# JOINT REGIONAL PLANNING PANEL (Sydney West)

## COUNCIL ASSESSMENT REPORT

<b>Panel Reference</b>	2016SYW093
<b>DA Number</b>	DA-970/2015
<b>LGA</b>	Liverpool City Council
<b>Proposed Development</b>	Construction of a 4-storey residential flat building above basement car park containing 23 residential apartments (14x1 bedroom and 9x2 bedroom)
<b>Street Address</b>	LOT 100 DP 1214405 188-190 Moore Street, Liverpool NSW 2170
<b>Applicant/Owner</b>	NSW Land and Housing Corporation
<b>Number of Submissions</b>	Nil
<b>Regional Development Criteria (Schedule 4A of the Act)</b>	Crown development with a Capital Investment Value (CIV) of more than \$5 million (\$6,896,045).
<b>List of all relevant s79C(1)(a) matters</b>	<p><i>List all of the relevant environmental planning instruments: s79C(1)(a)(i)</i></p> <ul style="list-style-type: none"> <li>• State Environmental Planning Policy No.65 – Design Quality of Residential Apartment Development.</li> <li>• State Environmental Planning Policy No.55 – Remediation of Land.</li> <li>• State Environmental Planning Policy (State and Regional Development) 2011.</li> <li>• State Environmental Planning Policy (Building Sustainability Index: BASIX) 20

Figure 6: 186 Moore Street ground floor plan (proposal RFB to the east)

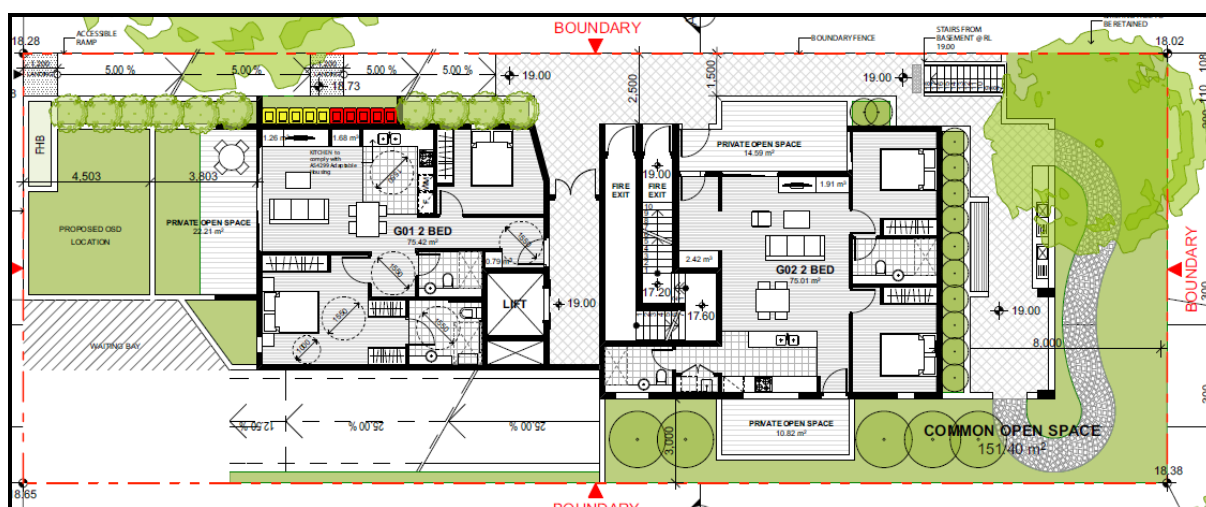
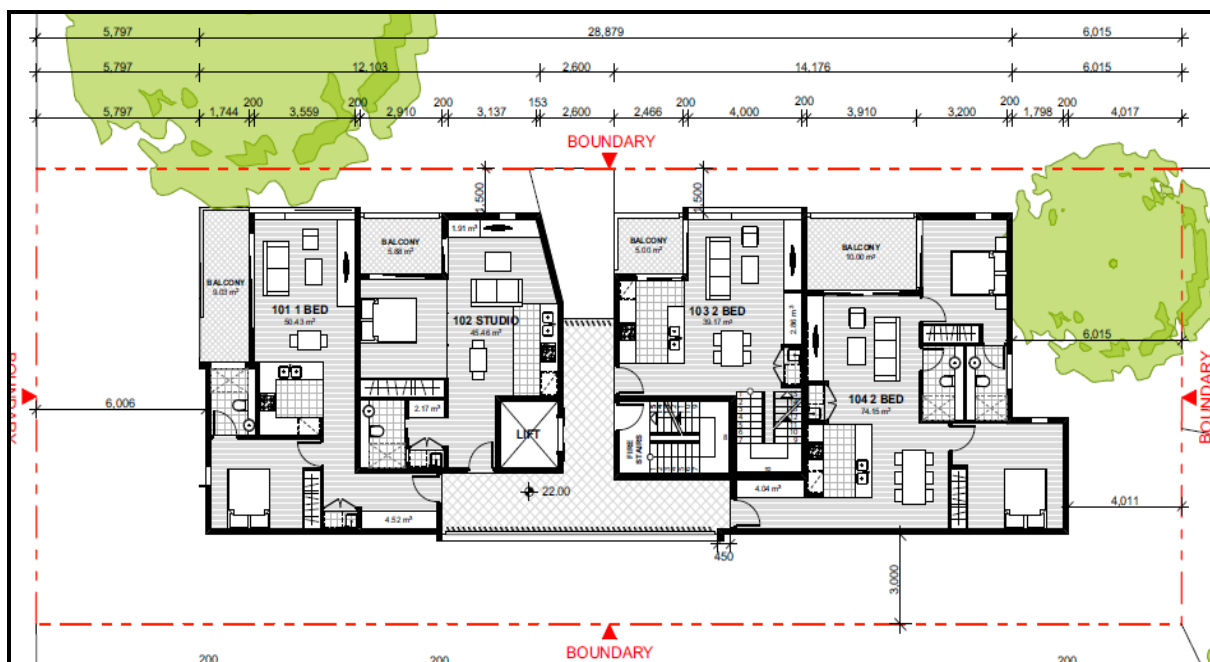
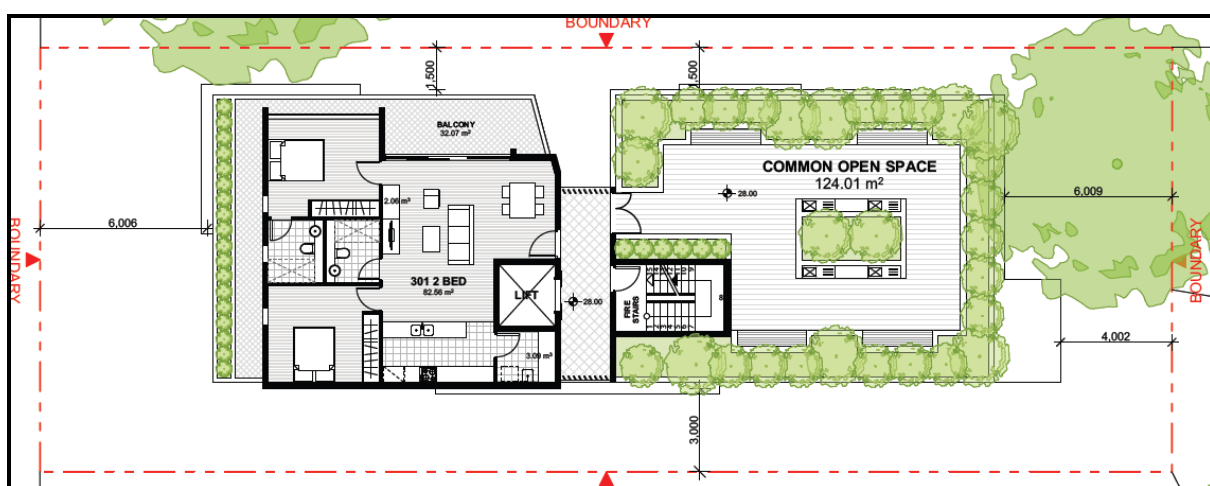
The adjoining site to the east at 186 Moore Street, Liverpool is subject to an RFB proposal currently before Council. The proposed 3 storey RFB shares a common boundary on its western side with the subject proposal (refer to Figures 6-8 for details). The adjoining proposal includes a private open space proposed at ground level which is considered unnecessary and should be deleted. With deletion of this balcony the ground floor dwelling would still be able to achieve compliance with ADG and LDCP 2008 private open space controls but importantly, would resolve any amenity issues between these two proposals. The private open space in question is a secondary POS and is not necessary and should be deleted.

The arrangement of the adjoining development's 1<sup>st</sup> and 2<sup>nd</sup> floors provides habitable rooms at the north and south ends of the western elevation, this layout supports adequate building separation as this aligns with the narrower portions of the subject proposal's built form. Overlooking to and from the adjoining site will be reduced by the arrangement of balconies at 186 Moore Street which are proposed along the eastern façade facing Alamein Park. It is also noted that the ground floor unit has windows off a kitchen and bedroom facing the subject site that are only 3m from its western boundary. As such these should be deleted/reduced.

It is considered that the proposed development has been designed with sufficient regard to the development potential of the eastern adjoining site and the manner in which the development has been conceived would allow the eastern adjoining site to be similarly re-developed. In doing so, the cruciform building of the proposal and the built form and arrangements of the eastern adjoining proposal are unlikely to create any unsatisfactory amenity issues in terms of visual/acoustic privacy and overshadowing problems. Accordingly, the building separation proposed by the proposal is considered acceptable.
